AQUATIC ASSESSMENT OPINION HIGHLANDS SOUTH WIND ENERGY FACILITY (WEF): PROPOSED AMENDMENTS TO THE ENVIRONMENTAL AUTHORISATION (DEFF REF: 14/12/16/3/3/1/1960)

EnviroSci (Pty) Ltd was appointed to review the proposed layout amendments against the previous aquatic impact assessment submitted in 2018/2019, noting that the Aquatic Impact Assessment was compiled by the same lead author as the undersigned.

FIGURE 1: Amended project layout (green lines), when compared to the observed watercourses with 32m buffer.

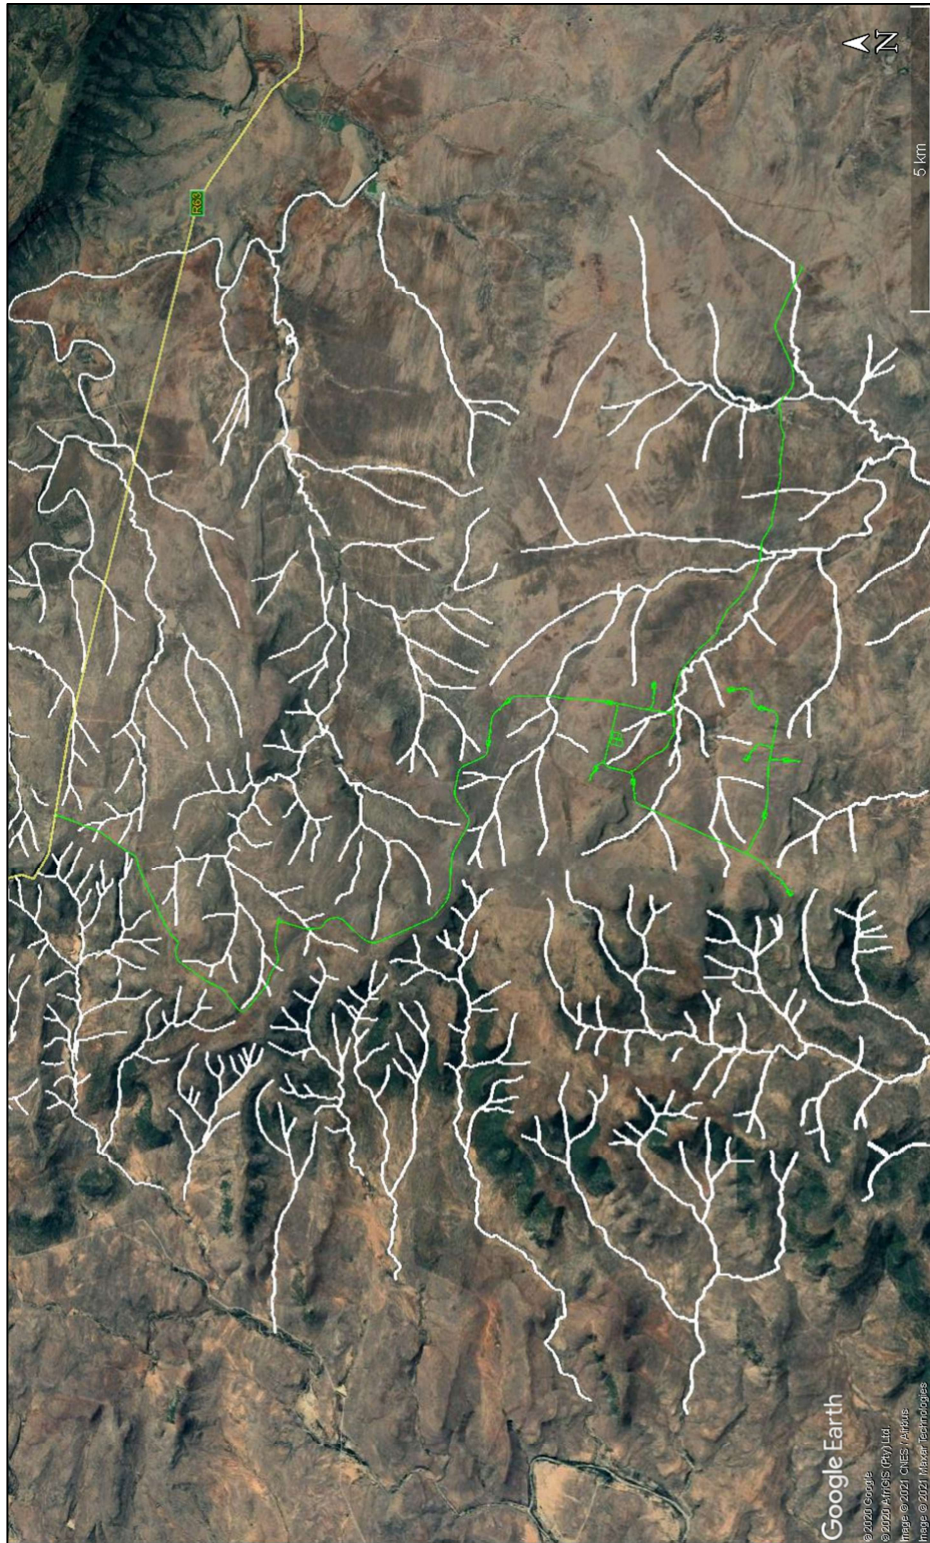
Table 2, summarises the findings of the impact assessment comparison between the authorised and amendment layout (Figure 1). As the impacts and their significance (with and without mitigation) were similar the reversibility, irreplaceability, extent, duration, severity, probability and status also remains unchanged, thus Table 2 only indicates the overall significance.

The proposed increased size of the turbines and increased footprint (of the turbine foundations and hardstandings) has had no direct impact on the aquatic environment, as the overall changes are mostly vertical (increases in height), which necessitated a change in the road layout (due to the reduction in the number of turbines), but more importantly the positions and changes to the associated infrastructure still avoid the most sensitive areas of the delineated aquatic zones including their respective buffers. This includes the proposed Battery Energy Storage System.

In conclusion, the potential impact of the proposed amendments and amended layout on the aquatic environment will remain unchanged from the original impact assessment if all the proposed mitigations are upheld. There is however an overall advantage to the proposed layout as the overall number of watercourse crossing has been reduced, although the impact significance would remain LOW for all the impacts.
